Access Compliance Report

Public Rights-of-Way

(Curb Ramps)

Intersection ID: 28107	Main Street: KNIGHTSDALE_DR	Cross Street: MITCHELL_GLEN_DR	Location: SE
ADA ID: 799793E97992	Ramp Type: PerpDiag	Initial Pass/Fail: Fail	Overall Compliance: No
Severity Score: 25			
Codes/Mitigation Info/Possible Solution		Field Measurements/Component Compliance

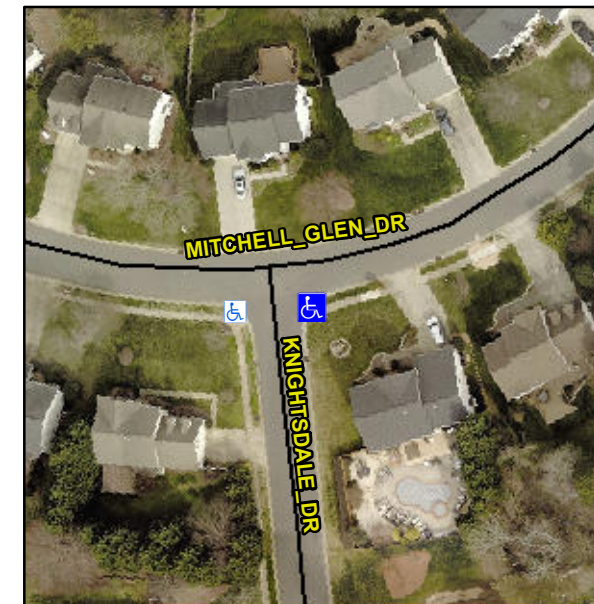
R304.2.2, R304.5.3

Compliance	Description	Data	Compliance	Description	Data
N/A	Ramp Length (in)	84.0	No	Ramp Slope (%)	8.9
Yes	Ramp Width (in)	48.0	No	Ramp XSlope (%)	6.2
N/A	Flare Type LT	N/A	N/A	Flare Type RT	N/A
N/A	Flare Slope LT (%)	N/A	N/A	Flare Slope RT (%)	N/A
N/A	Flare Traversable LT?	N/A	N/A	Flare Traversable RT?	N/A
N/A	Landing Length (in)	N/A	N/A	DWS Provided?	N/A
N/A	Landing Width (in)	N/A	N/A	DWS Contrast?	N/A
N/A	Landing Slope (%)	N/A	N/A	DWS Length (in)	N/A
N/A	Landing X Slope (%)	N/A	N/A	DWS Full Width?	N/A
N/A	Landing Curb? (Y/N)	N/A	N/A	DWS Offset (in)	N/A
N/A	Shared Landing?	N/A			
N/A	Gutter Ponding?	N/A	N/A	Gutter Slope (%)	N/A
N/A	Gutter Lip Ht (in)	N/A	N/A	Gutter X Slope (%)	N/A
N/A	Painted X Walk1?	No	N/A	Painted X Walk2?	No
	X Walk 1 Direction	To N		X Walk 2 Direction	To W
N/A	X Walk 1 Width (in)	N/A	N/A	X Walk 2 Width (in)	N/A
	X Walk 1 Slope (%)	1.1		X Walk 2 Slope (%)	3.2
	X Walk 1 X Slope (%)	2.7		X Walk 2 X Slope (%)	0.7

N/A	Ramp inside XWalk1?	N/A	N/A	Ramp inside XWalk2?	N/A
	Road Slope (%)	1.2	N/A	Clear Space?	N/A
	Road X Slope (%)	4.9	N/A	Clear Space to XWalk (in)	N/A
N/A	Any Obstructions?	N/A	N/A	Storm Grate/Utility Hazard?	N/A
	Obstruction Type			Storm Grate/Utility Type	
		N/A			N/A
			Yes	Surface Condition? (G/P)	Good

Remove & Replace Curb Ramp With Two New Directional Ramps or Equivalent.
